DESIGN REVIEW & PRESERVATION BOARD

LOCATION: 1418 20th Street

PROPOSAL: New Construction, 2-story office building

DR 83-102

A-3

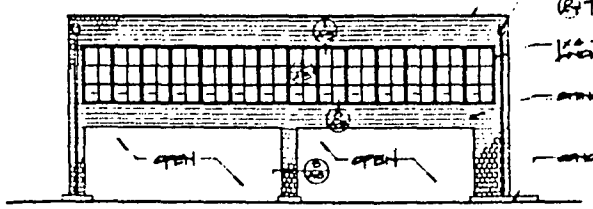
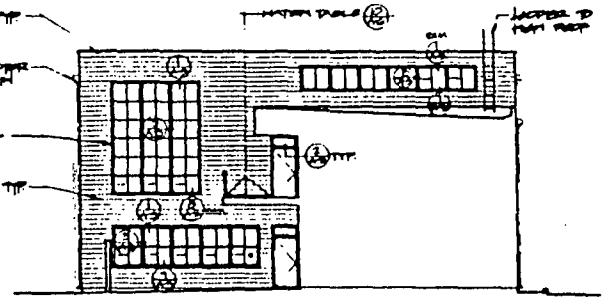
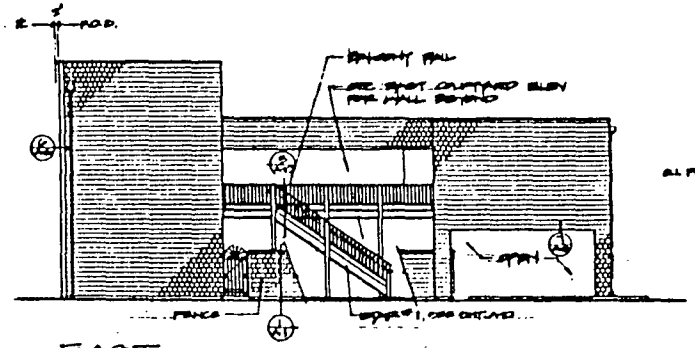
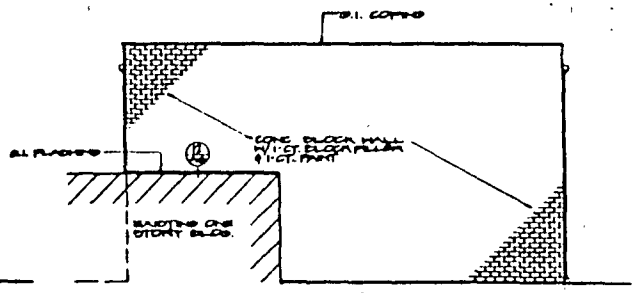
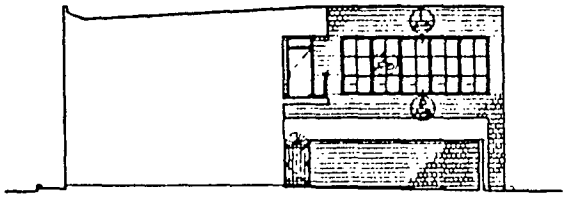
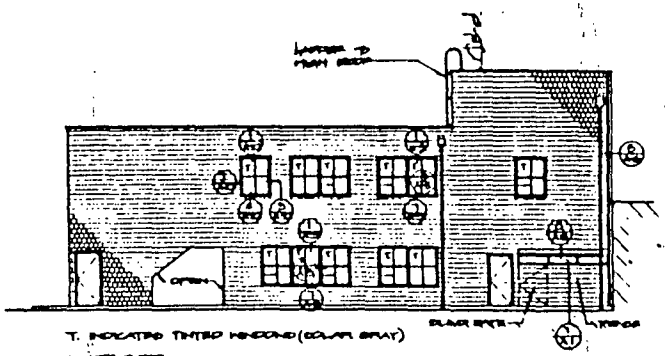
The proposal through the use of wood shingles and wood trim picks up the softer tone and feel of the older residential buildings. Unfortunately, this integrative use of material is overpowered by the strong rectilinear massing of the new structure. Even though most of the older residential buildings along the street are rectangular in bulk, each is topped by a hip or gable roof. The slopes and ridge height of each roof contributes to the rhythm of the streetscape. This project by the use of a horizontal parapet and flat roof deviates from the rhythm of the street and neighborhood.

All of the existing residential buildings and some of the commercial buildings allow their facades to be open to the street through the use of window and door openings facing the front sidewalk. Notwithstanding the central courtyard with its eastern face having door and window openings and the open ground level area leading to the alley parking, this project faces the street with primarily two blank shingle walls.

Staff feels that a major fault of this project is the lack of the building's ability to blend into the streetscape.
